May 31, 2024

RE: **CAO24-011** Review Letter 1; 8020 SE 57th St, Mercer Island, WA 98040

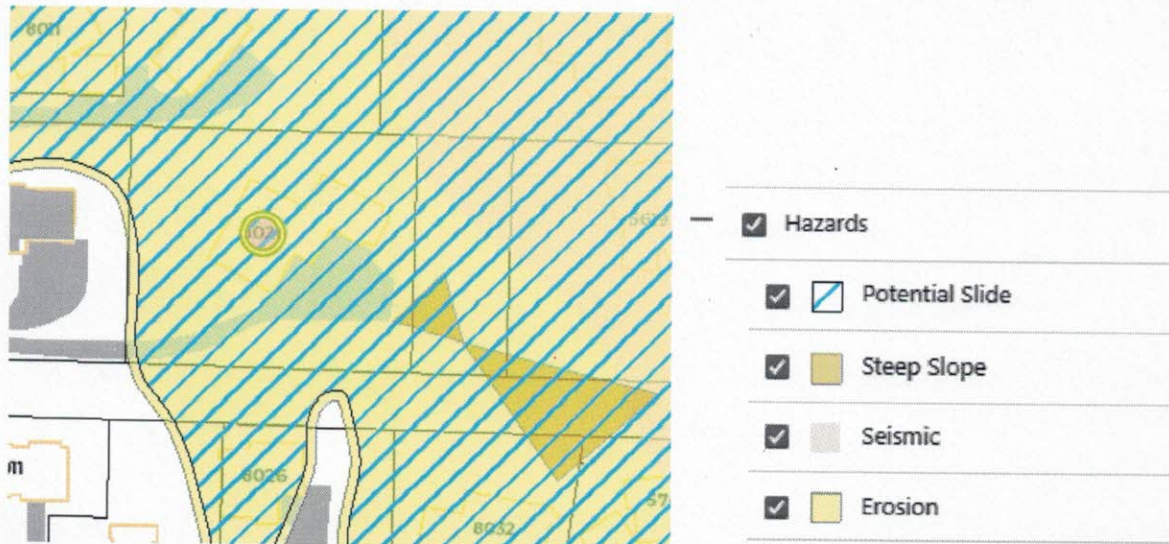
- ✓ 5. The submitted Geotechnical Engineering report does not discuss the required buffers for the mapped steep slope at the southeast corner of the property (see image below). [MICC 19.07.160](#)(C)(2)(a) requires a buffer equal to the height of the steep slope applied to the top and toe of slope, or, (b) if this could be considered a shallow landslide hazard area, a minimum 25-foot buffer applied in all directions. Please have the geotechnical engineer address this steep slope area, as a buffer

might be required that may encroach onto the subject property. If a buffer is required, please update the plan set to show this.
